**Report: TAB Report**  
**Function: Test, Adjust, & Balance**  
**Date: 06/10/2024**

**PROJECT**  
**08-26-24 WAWA #5443 YULEE, FL**

## Project Summary

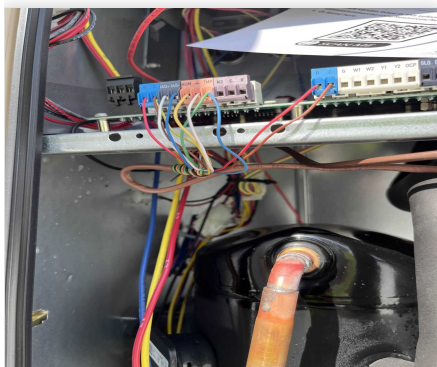
**Issue Name :** EF 2 No Speed Controller  
**Description :** No speed controller located. Manual damper installed on fan inlet. Recommend removing damper and installing speed controller per M3.0 HVAC EXHAUST FAN SCHEDULE.  
**Created By :** National TAB                      **Assigned To :** National TAB - Will Turnbough  
**Status :** Open  
**Priority :** Urgent                                      **Asset Tag :**  
**Originated Date :** 06/13/2024 - Stephen Tassinaro - National TAB

- **08/27/2024**    **National TAB - Kristopher Passley**
  - DAMPER REMOVED AND SPEED CONTROLLER INSTALLED

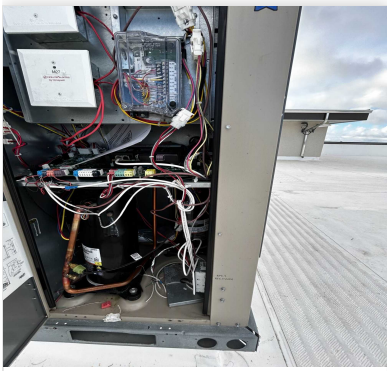
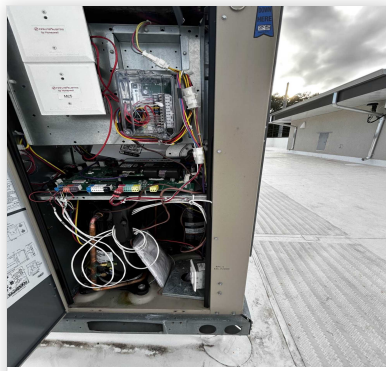
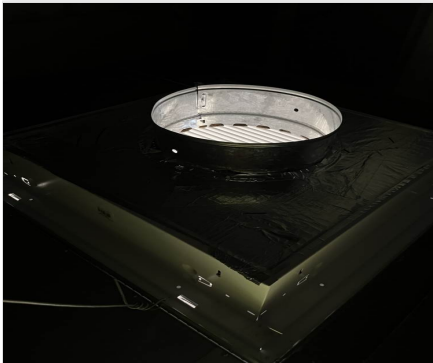
**Issue Name :** Remote Sensor Wiring  
**Description :** The remote humidity sensor wiring does not match the specification shown on the mechanical plans. 2 conductor shielded cable (Qty 2) was not used. Standard thermostat cable used for all sensors. Attached picture typical of all RTUs.  
**Created By :** National TAB                      **Assigned To :** National TAB - Will Turnbough  
**Status :** Open  
**Priority :** High                                      **Asset Tag :**  
**Originated Date :** 06/12/2024 - Stephen Tassinaro - National TAB

- **08/27/2024 National TAB - Kristopher Passley**
  - REMOTE HUMIDITY SENSORS WIRING NOT REPLACED

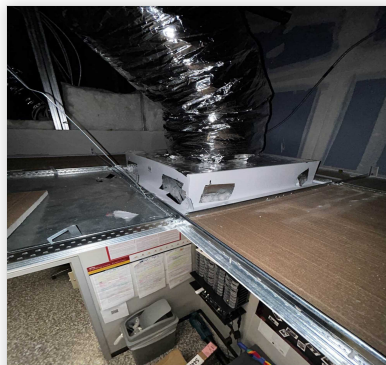
**Issue Name :** Return Grille Not Connect To Duct  
**Description :** The return grille located in the ASSOCIATES room is not connected to the duct in the ceiling. Recommend connecting.  
**Created By :** National TAB                      **Assigned To :** National TAB - Will Turnbough  
**Status :** Open  
**Priority :** Medium                                      **Asset Tag :**  
**Originated Date :** 06/13/2024 - Stephen Tassinaro - National TAB

- **08/27/2024 National TAB - Kristopher Passley**
  - RETURN GRILLE IS DUCTED
